STAFF RECOMMENDATION

1817 Sweetbriar Avenue
November 19, 2018

Application: New Construction—Infill

Description of Project: Application is to construct detached duplex infill on a one hundred foot (100') wide lot.

'A' ELEVATIONS

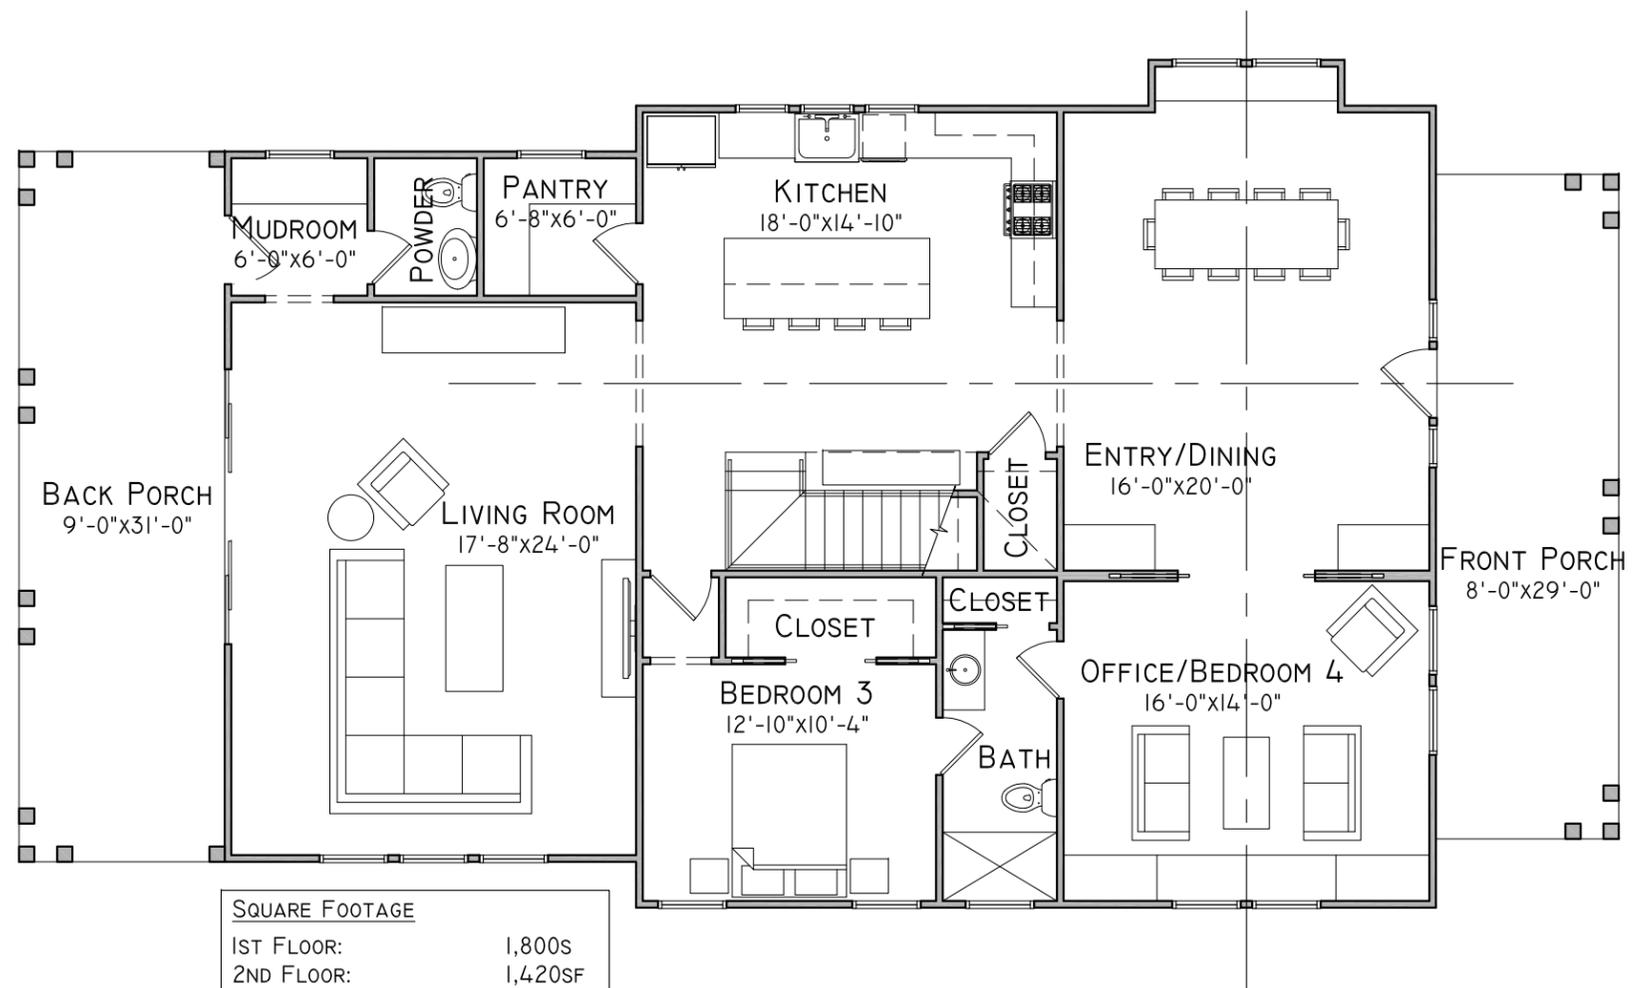
*On “House A,” the applicant is proposing a brick foundation at the front, with a brick porch floor and possibly brick steps. Historically, there was a change in material from the foundation to the wall above; MHZC has typically required a stone, stucco, or split-faced concrete block foundation with a brick wall. Also, a brick porch floor is not typical for historic houses, as porch floors were typically concrete or wood. Staff recommends that there be a change in material at the foundation level, and that the front porch be wood or concrete.

Roof form: “House A” has a steeply-pitched cross gable roof form with a 14/12 slope. There is a flat-roofed bay on the left façade with, which will provide a small balcony at the second level. Staff finds this proposed flat-roof portion to be appropriate, as it is a secondary roof form, on the side façade about twenty-two feet (22’) back from the front. The left façade contains a shed dormer. The right façade has a two-story shed roofed bay. Staff finds that “House A’s” roof form meet the design guidelines.

Staff recommends approval of a brick sample, all windows and doors, and the shingle and metal roofs color and texture. With the conditions that “House A” have a change in material at the foundation line and that its porch floor be wood or concrete; that the foundation on “House B” be split faced; and that staff approve all final material choices, staff finds that the known materials meet Section II.B.1.d. of the design guidelines.

'B' ELEVATIONS
B2.0

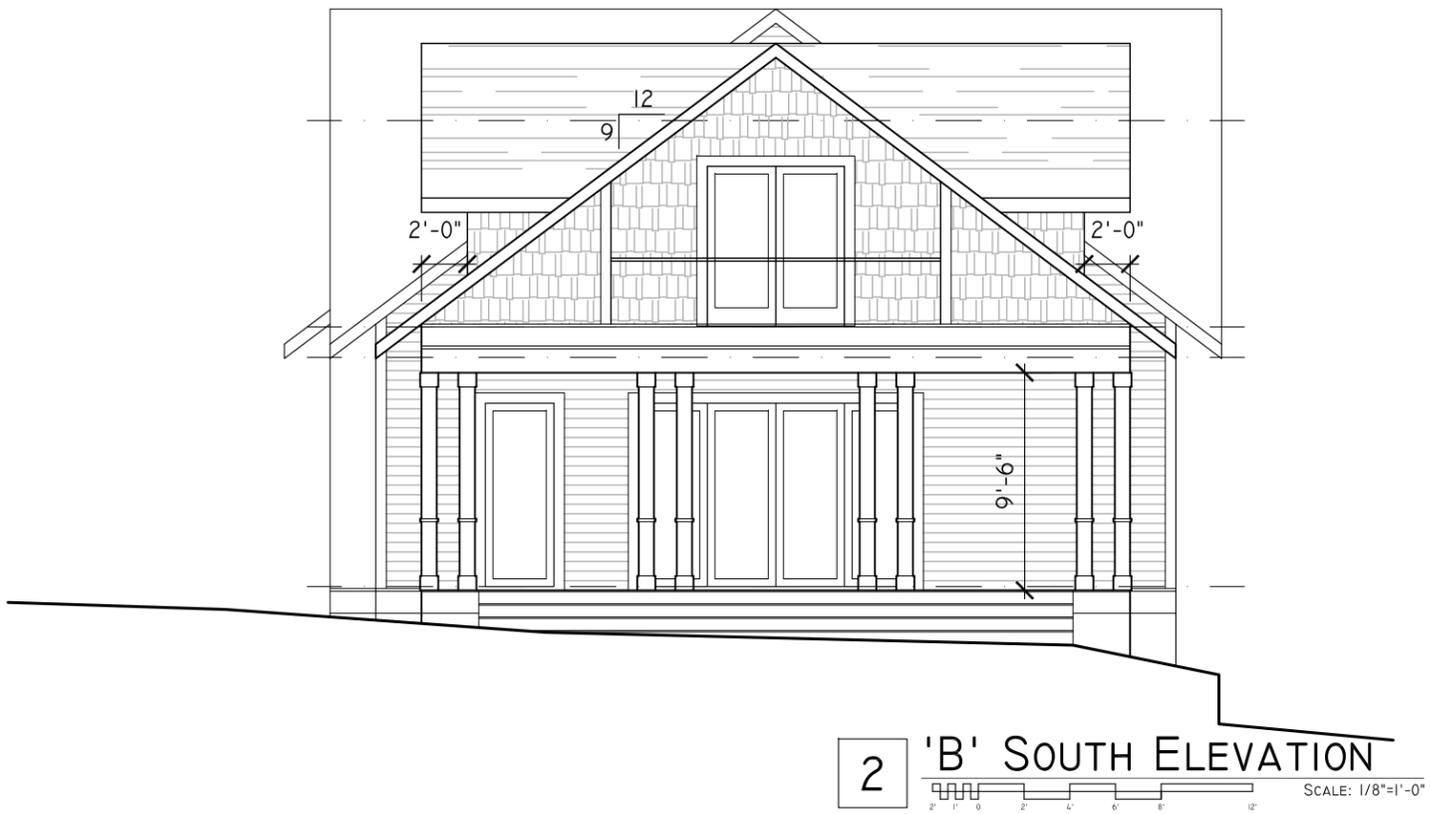
** Staff recommends that the block for the foundation on “House B” be split faced.

“House B” will have a cross-gabled roof form with a 9/12 slope. The side elevations will have 8/12 gabled dormers that are inset two feet (2’) from the wall below. The porch roof is hipped with a 4/12 slope. Staff finds that “House B’s” roof form meets the design guidelines.
